SUBJECT: UNIT 1 OFFSITE DOSE CALCULATION MANUAL Revision 11

OFFSITE DOSE CALCULATION MANUAL

UNIT 1

S01-ODCM
Revision 11
12-06-95

Figure 5-3 P. 5-28

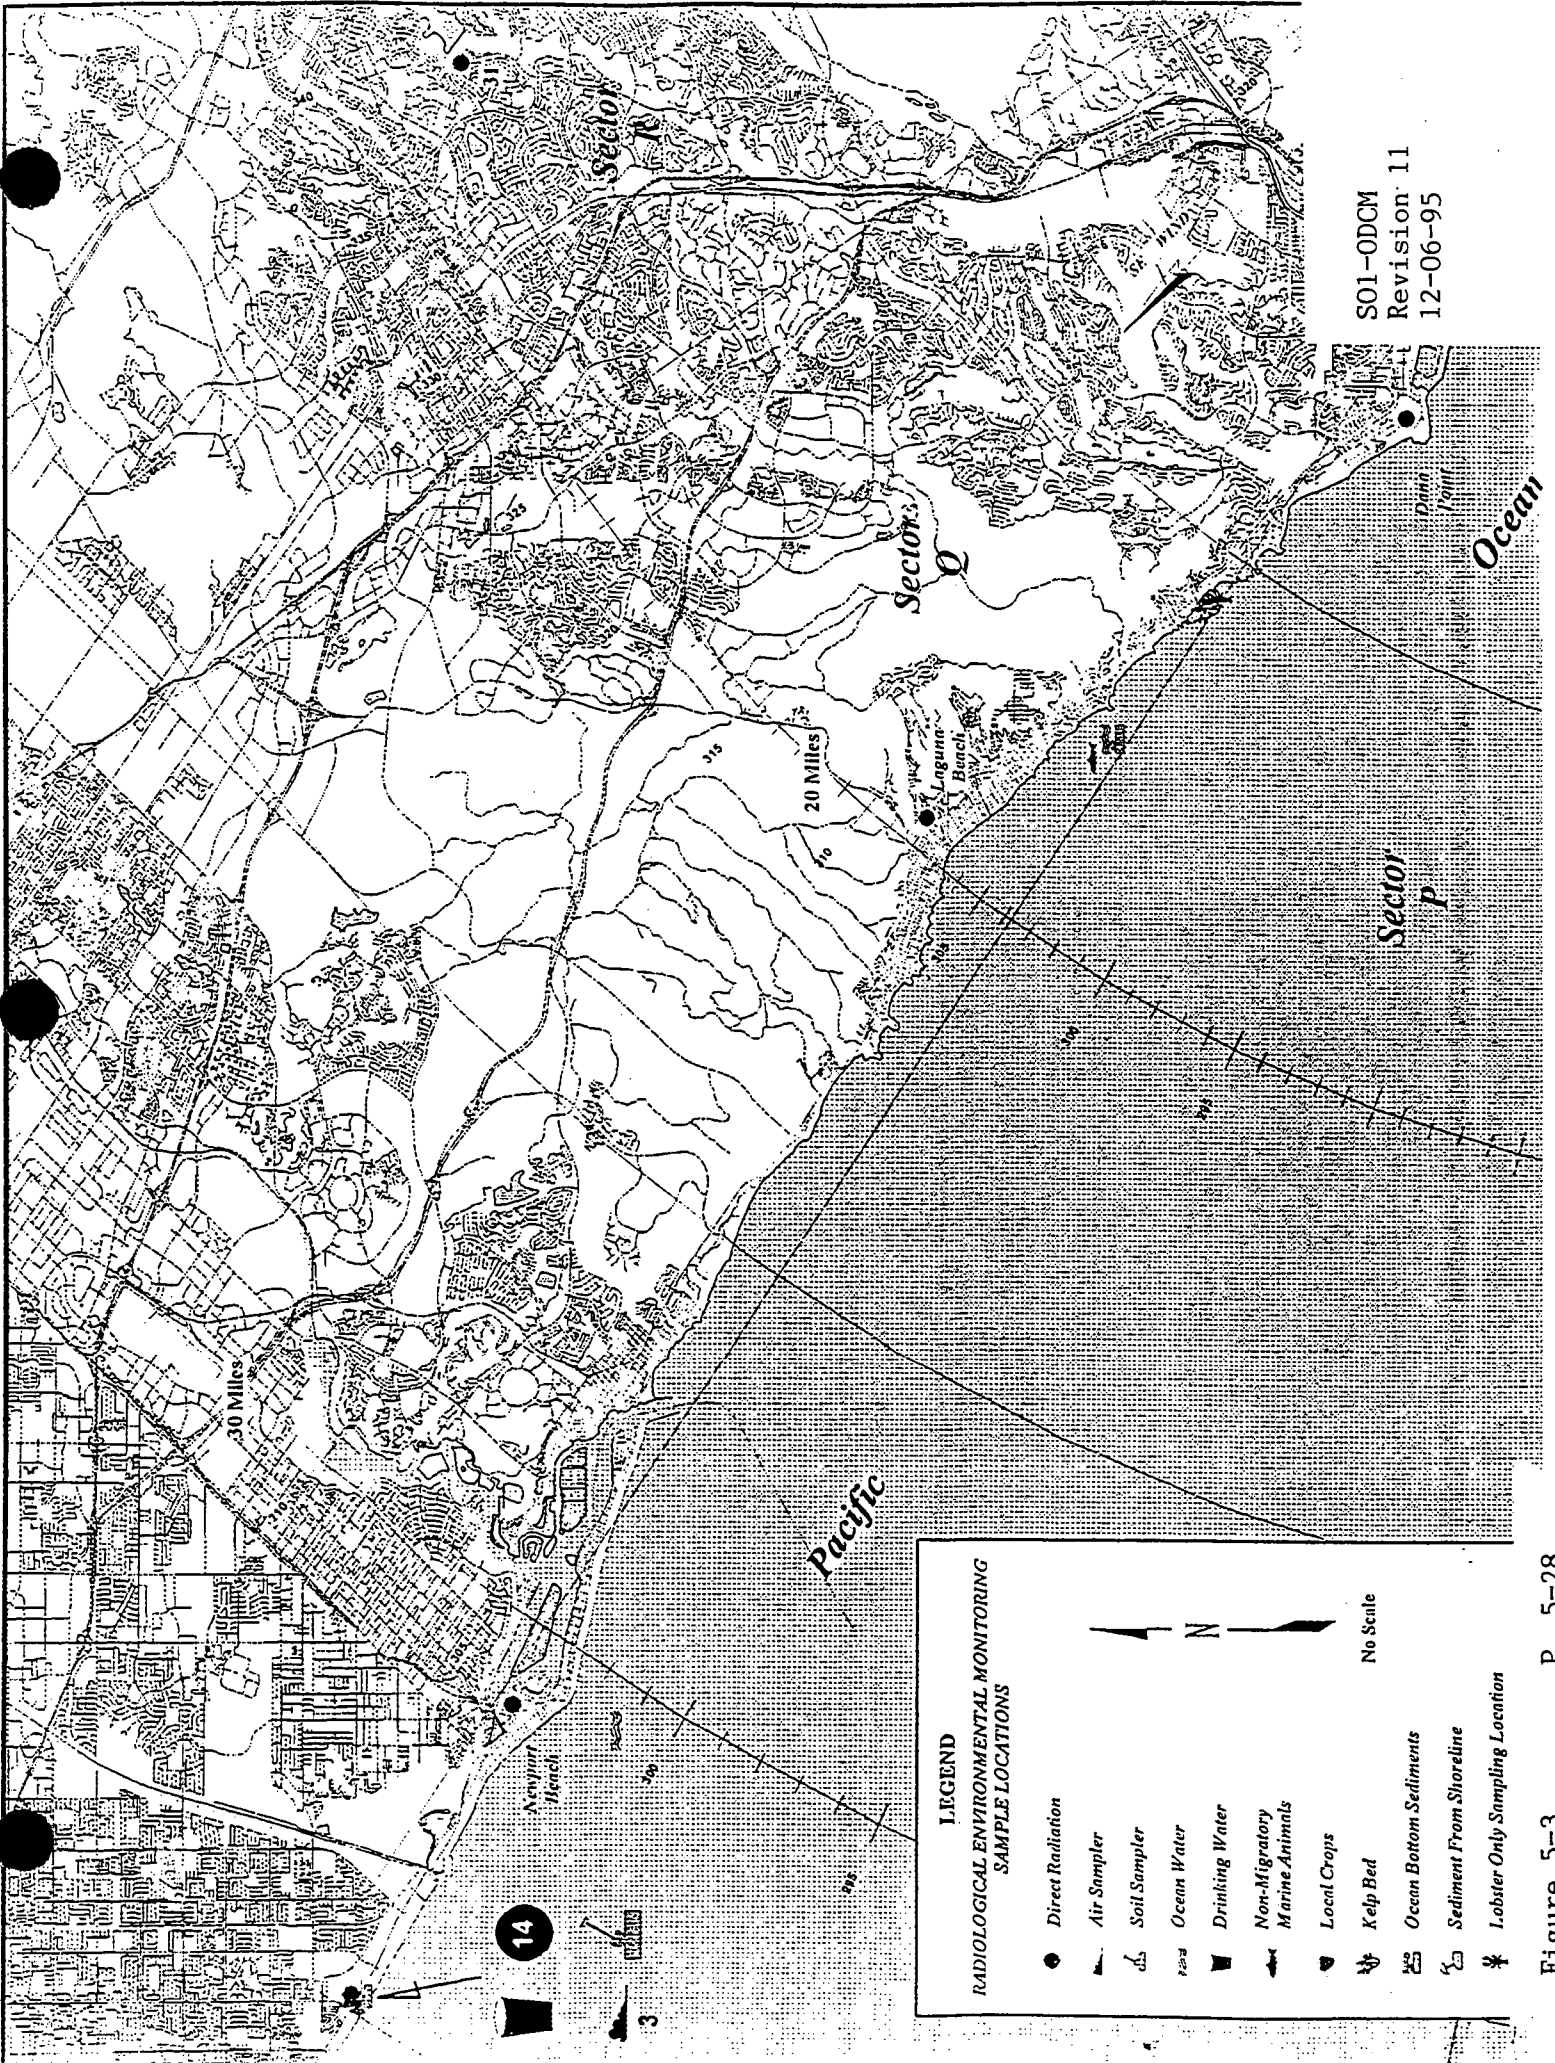
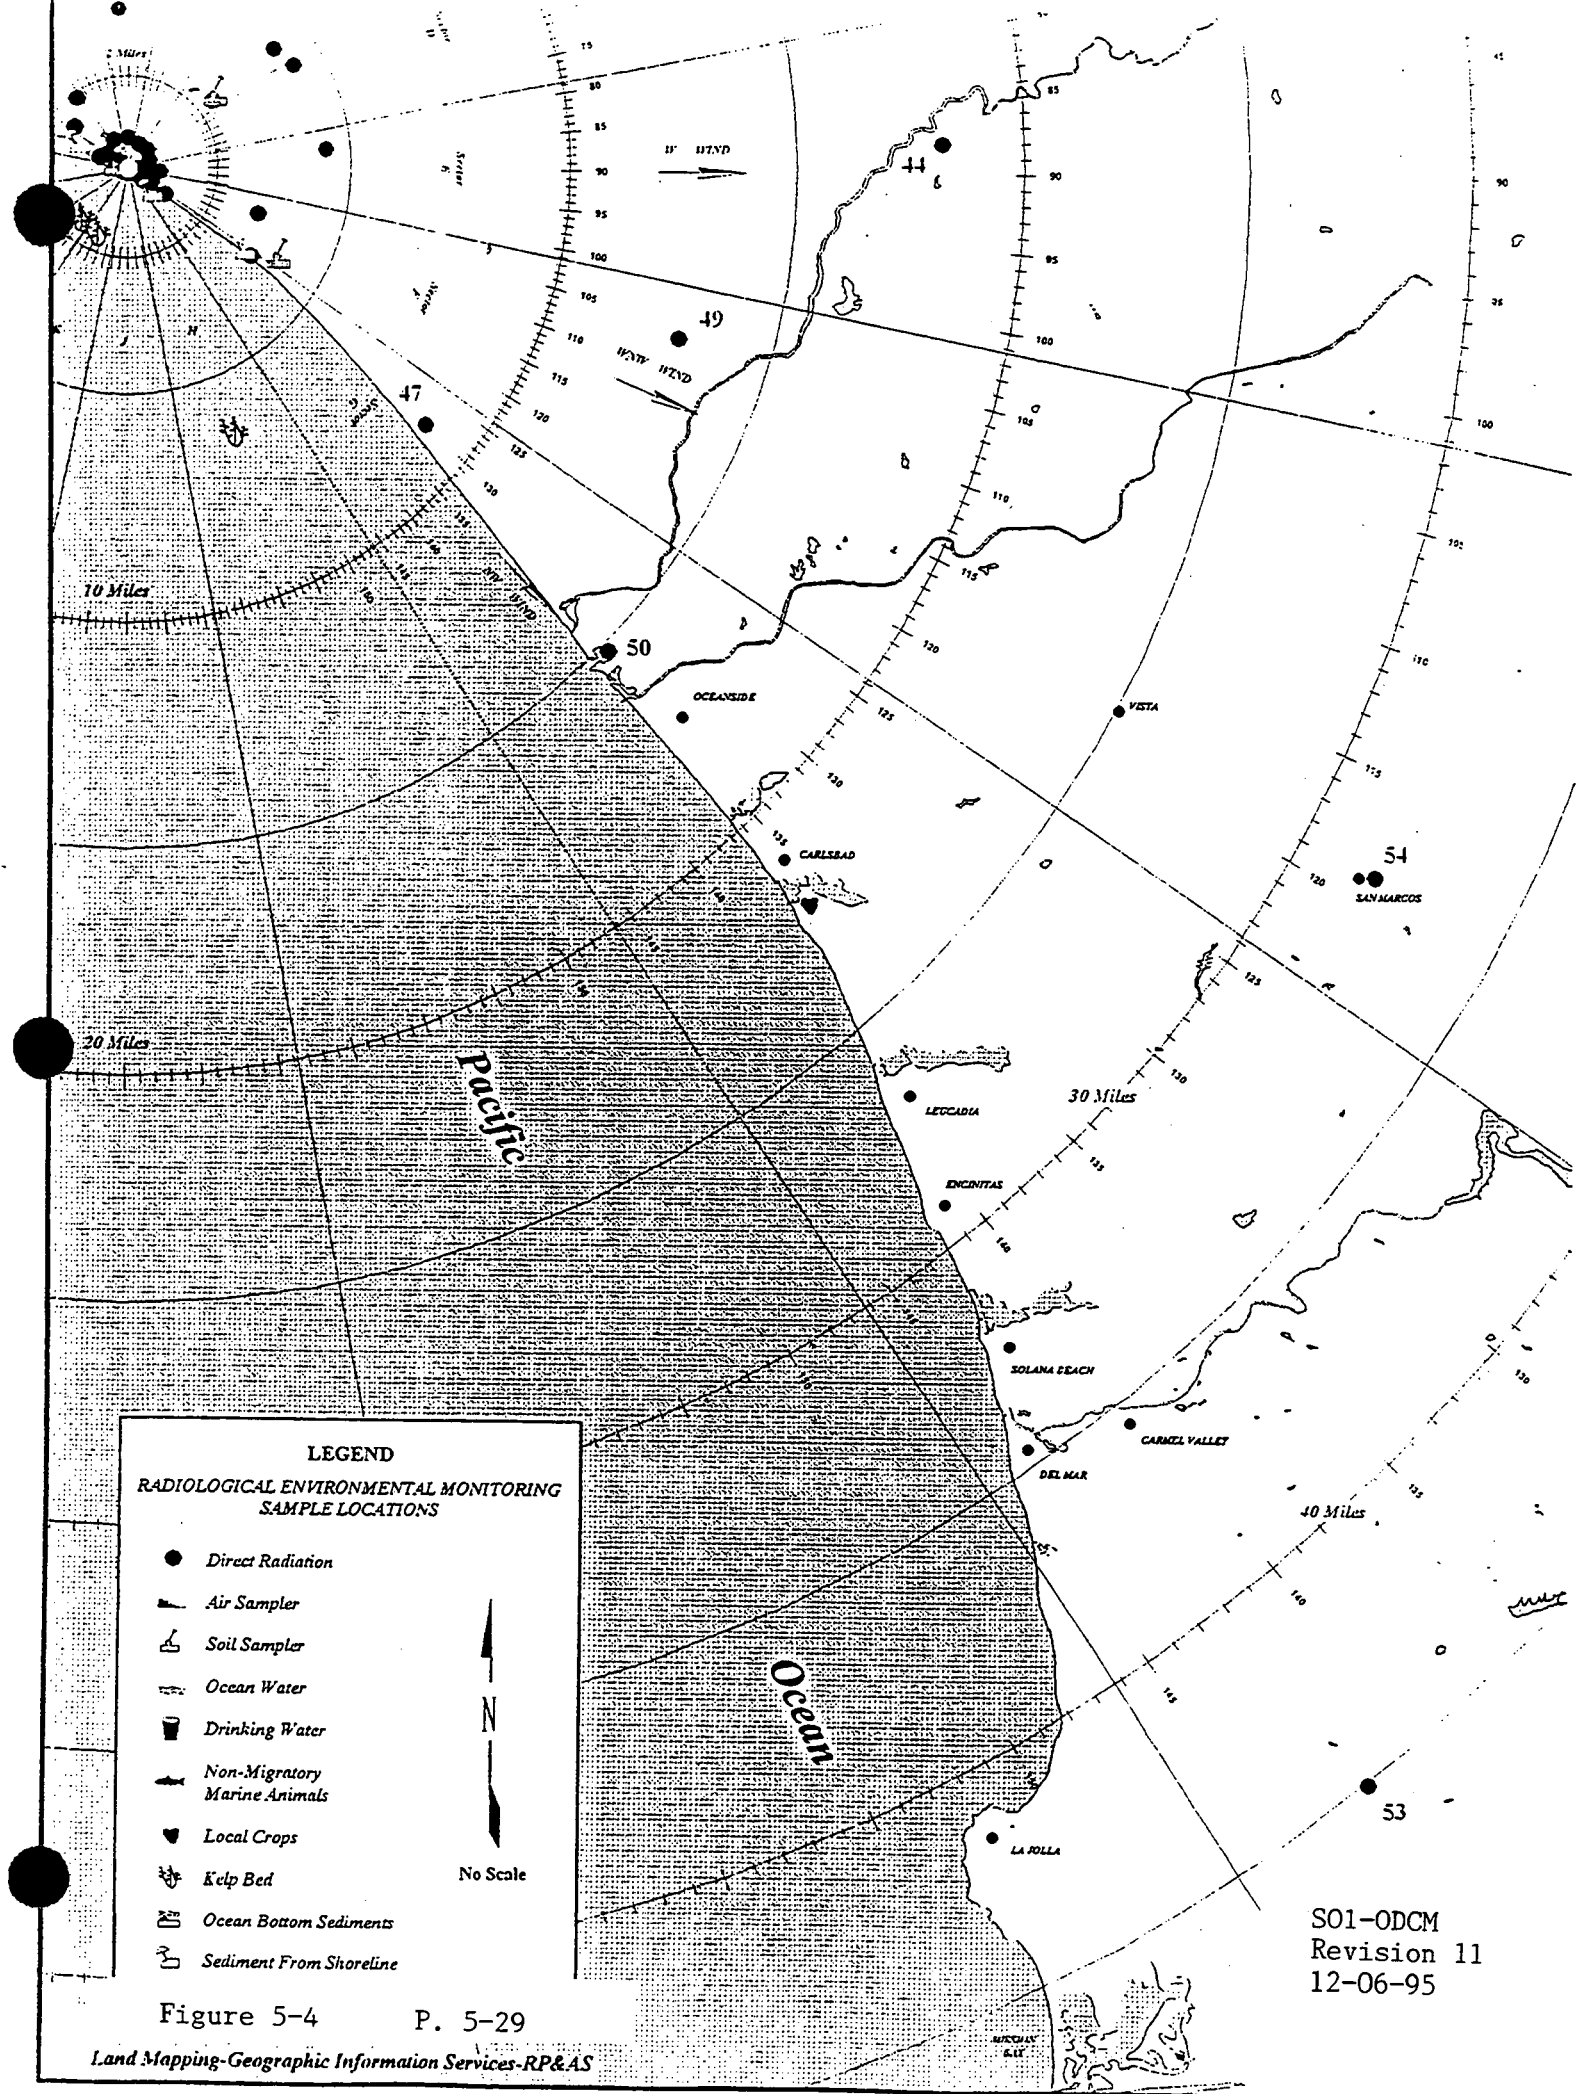
- iv Changed the word Operability to Functionality to be consistent with text of ODCM (which was revised in Revision 10) and Unit shut down condition.
- vi Replaced the previous three figures with four new figures, as supplied in the Land Use Census. The same basic information is contained in the new figures.

- 5-26- Replaced existing three figures with new versions supplied in Land Use
5-29 Census. Added a page to account for new fourth page. The same information is contained in the new figures.
